SUBJECT: Forwards revised FSAR figures documenting analyses of SER
 Confirmatory Issue 1 re final pipe break locations & design
 of pipe whip restraints. Final break locations based on
 completion of as-built programs & final stress analysis.

Subject: NUCLEAR PROJECT NO. 2
SAFETY EVALUATION REPORT, CONFIRMATORY
ISSUE (1) BREAK LOCATIONS

The subject confirmatory issue requires submittal of the results of analyses to determine final pipe break locations and final design of pipe whip restraints. Attached are the revised FSAR figures documenting these analyses. It should be noted that these revisions indicate break locations based on the "status as built" stress analysis with thermal and fatigue loads. The "status as built" is not a final "as built" configuration; however, the Supply System does not anticipate any significant differences. Hence, the stress analysis and resulting pipe break locations in the attached figures, although not based on a final "as built", will not differ significantly from the final break locations. The final break locations will be based on completion of the "as built" program and the final stress analysis. Although no changes are anticipated, the Supply S

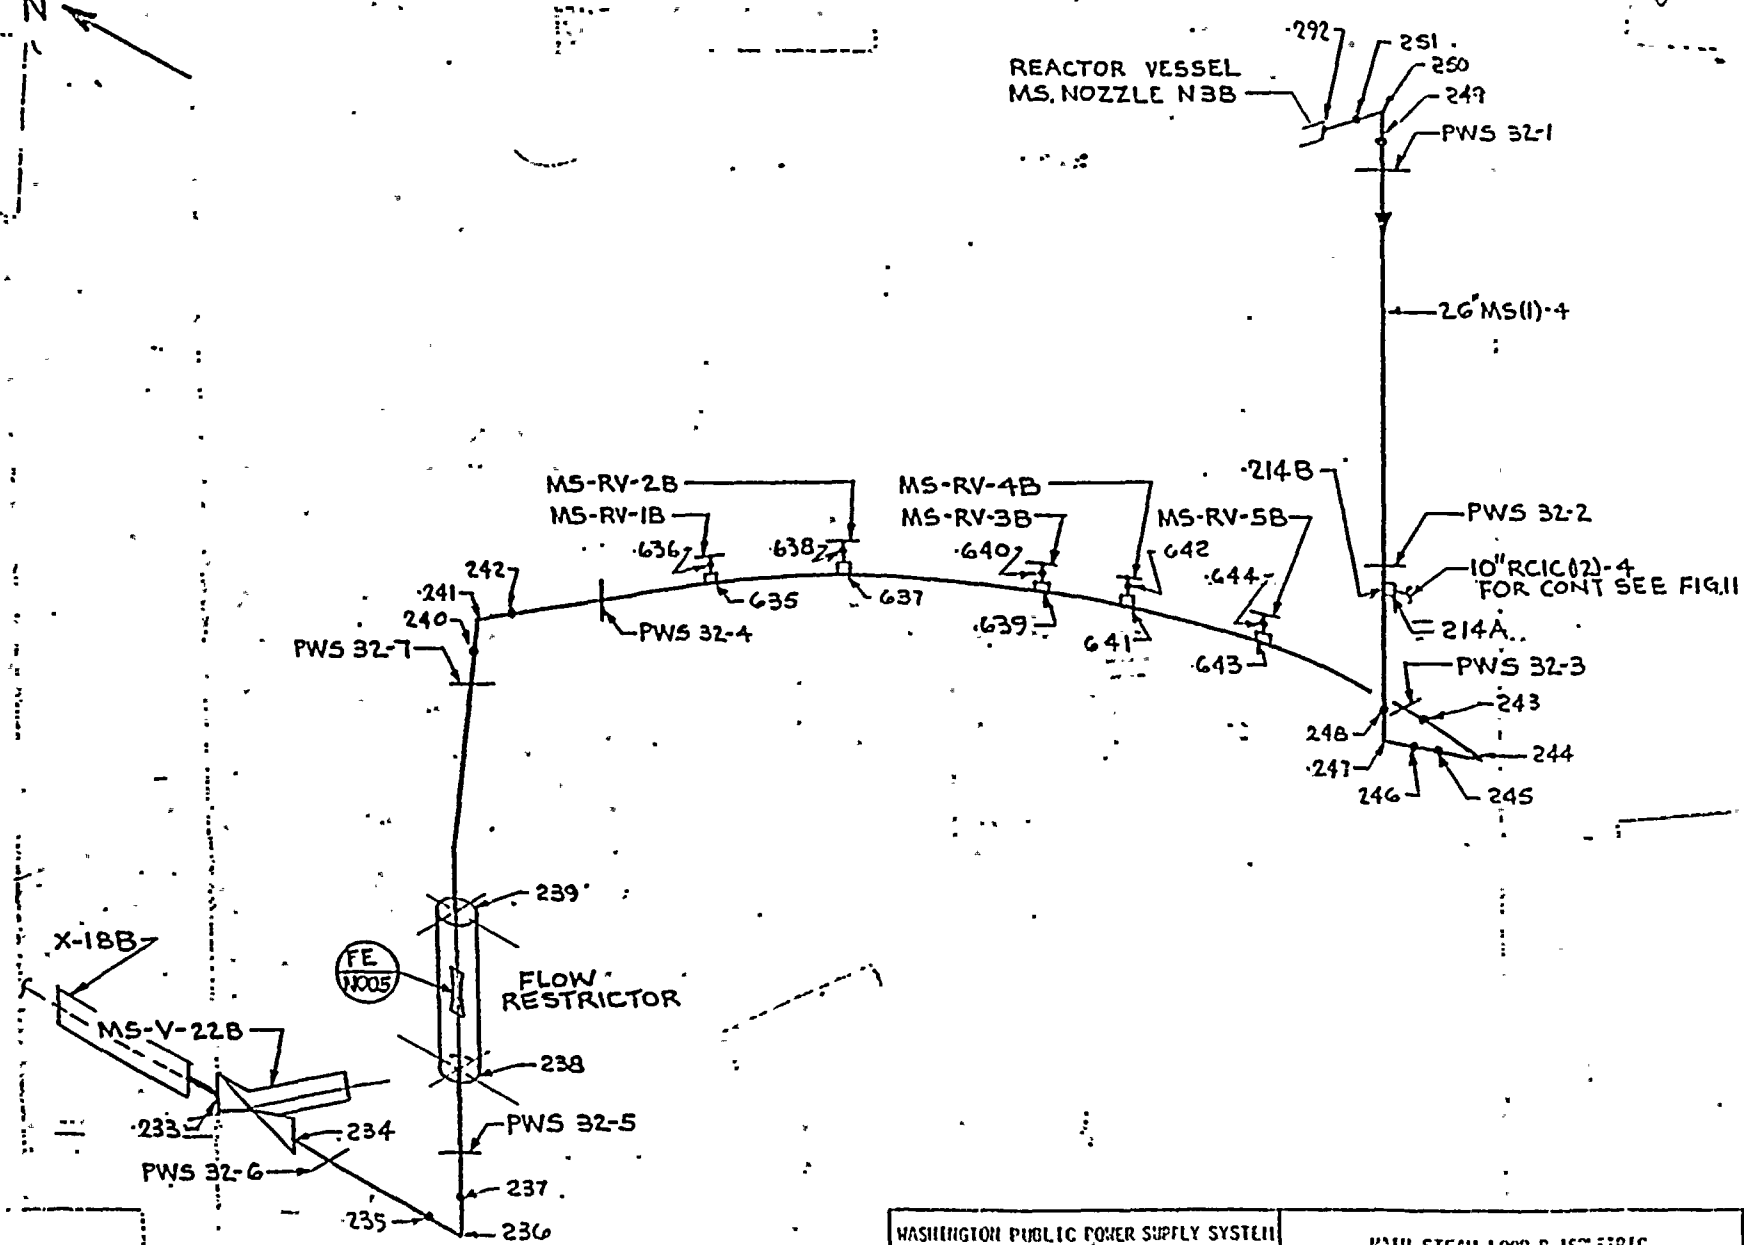
SUMMARY OF POSTULATED PIPE BREAK LOCATIONSCIRCUMFERENTIAL BREAKS

~~Node 215~~
Node 216.
~~Node 217~~
Node 219.
Node 221.
~~Node 222~~
~~Node 223~~
Node 224.
Node 226.
Node 227.
Node 229.
Node 230.
Node 232.
Node 291.
~~Node 628~~
~~Node 630~~
~~Node 632~~
~~Node 634~~
~~Node 633~~
~~Node 631~~
~~Node 629~~
~~Node 627~~

LONGITUDINAL BREAKS

~~Node 218~~
Node 220.
Node 225.
Node 228.
Node 231.
Node 633
Node 631
Node 629
Node 627

FIGURE
1.6-13

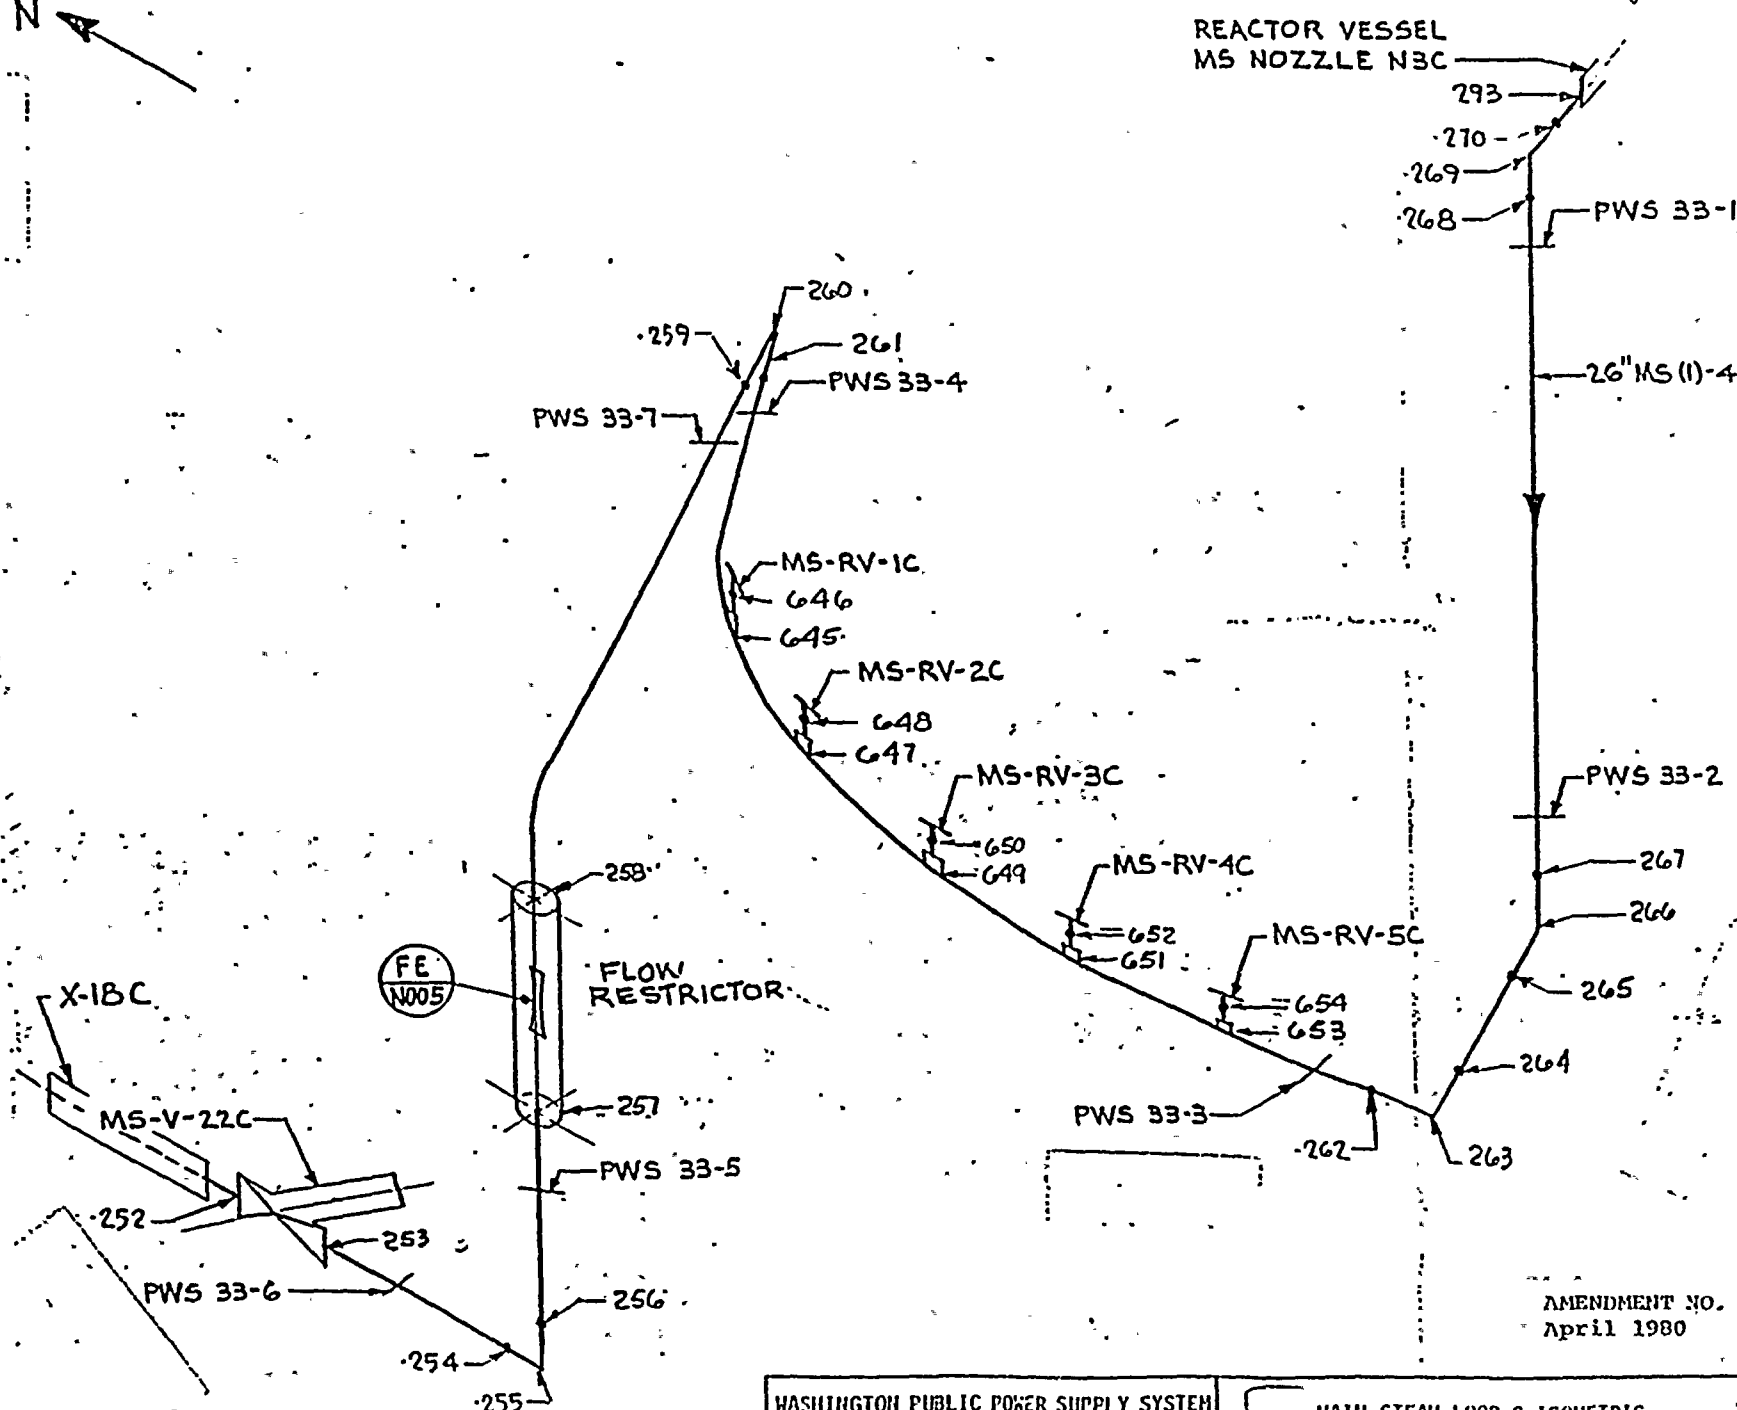
SUMMARY OF POSTULATED PIPE BREAK LOCATIONS

CIRCUMFERENTIAL BREAKS

~~Node 233~~
~~Node 234~~
Node 235
Node 237
~~Node 238~~
~~Node 239~~
Node 240
Node 242
~~Node 243~~
~~Node 245~~
Node 246
Node 248
Node 249
Node 251
Node 292
Node 636
~~Node 638~~
Node 640
~~Node 642~~
Node 644
NODE 214A
~~NODE 643~~
~~NODE 644~~
~~NODE 639~~
~~NODE 637~~
~~NODE 635~~

LONGITUDINAL BREAKS

Node 236
Node 241
~~Node 244~~
Node 247
Node 250
NODE 643
NODE 641
NODE 639
NODE 637
NODE 635

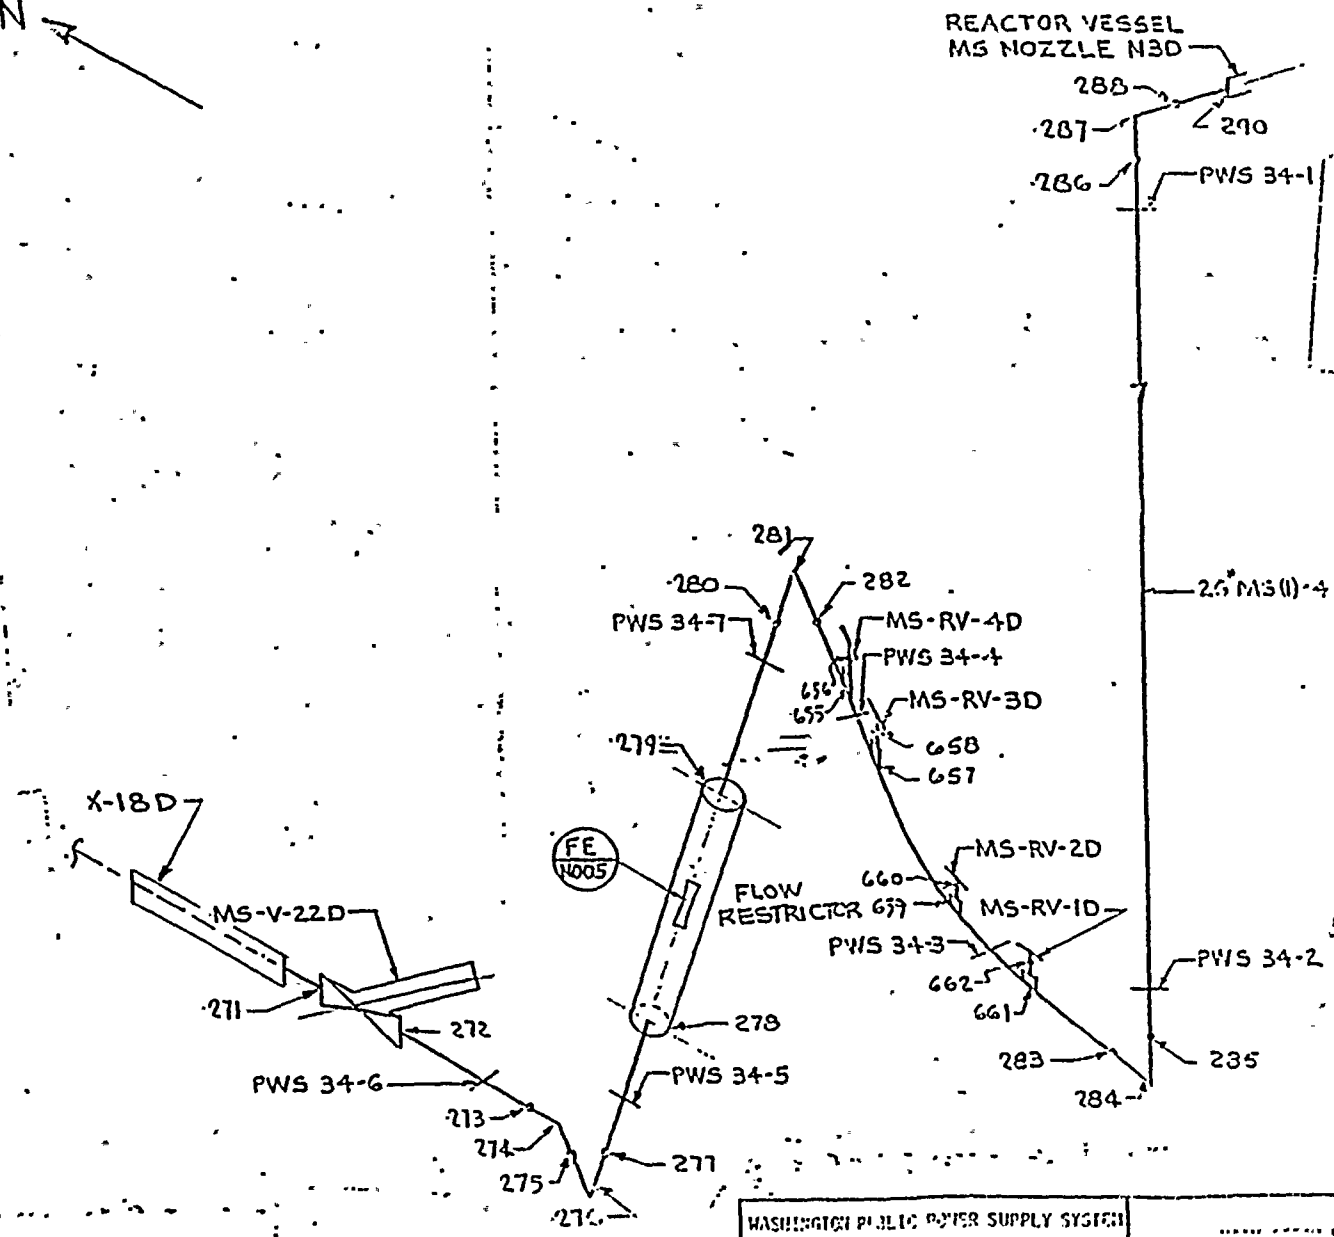
SUMMARY OF POSTULATED PIPE BREAK LOCATIONSCIRCUMFERENTIAL BREAKS

~~Node 252~~
~~Node 253~~
Node 254'
Node 256'
~~Node 257~~
~~Node 258~~
Node 259'
Node 261'
~~Node 262~~
~~Node 264~~
Node 265'
Node 267'
Node 268'
Node 270'
Node 293'
Node 646' *NODE 646'*
~~Node 648~~
Node 650' *NODE 650'*
~~Node 652~~
Node 654'

LONGITUDINAL BREAKS

Node 255-
Node 260-
~~Node 263~~
Node 266-
Node 269-
NODE 653 -
NODE 651 -
NODE 649 -
NODE 647 -
NODE 645 -

FIGURE
2.6-1

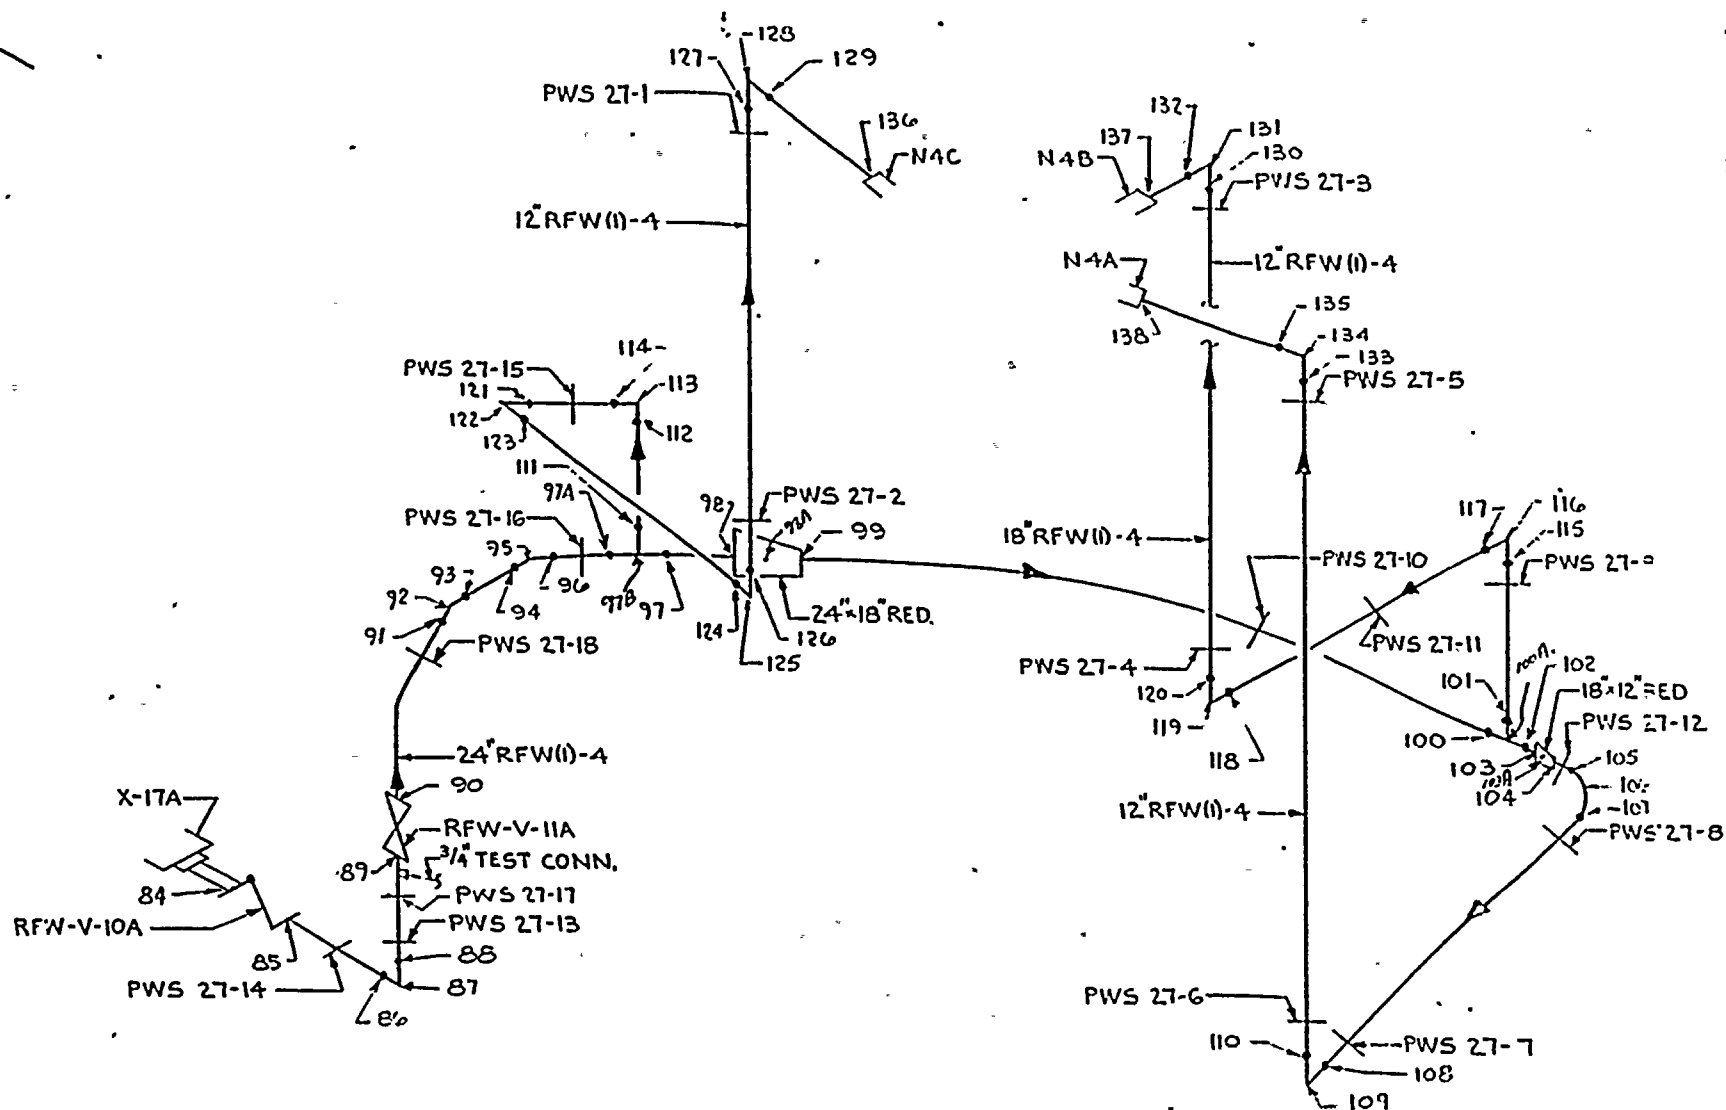
SUMMARY OF POSTULATED PIPE BREAK LOCATIONSCIRCUMFERENTIAL BREAKS

~~Node 271~~
Node 272.
~~Node 273~~
Node 275.
Node 277.
~~Node 278~~
~~Node 279~~
Node 280.
Node 282.
Node 283.
Node 285.
Node 286.
Node 288.
Node 290.
~~Node 656~~
~~Node 658~~
~~Node 660~~
~~Node 662~~

LONGITUDINAL BREAKS

~~Node 274~~
Node 276.
Node 281.
Node 284.
Node 287.
NODE 661.
NODE 659.
NODE 657
NODE 655
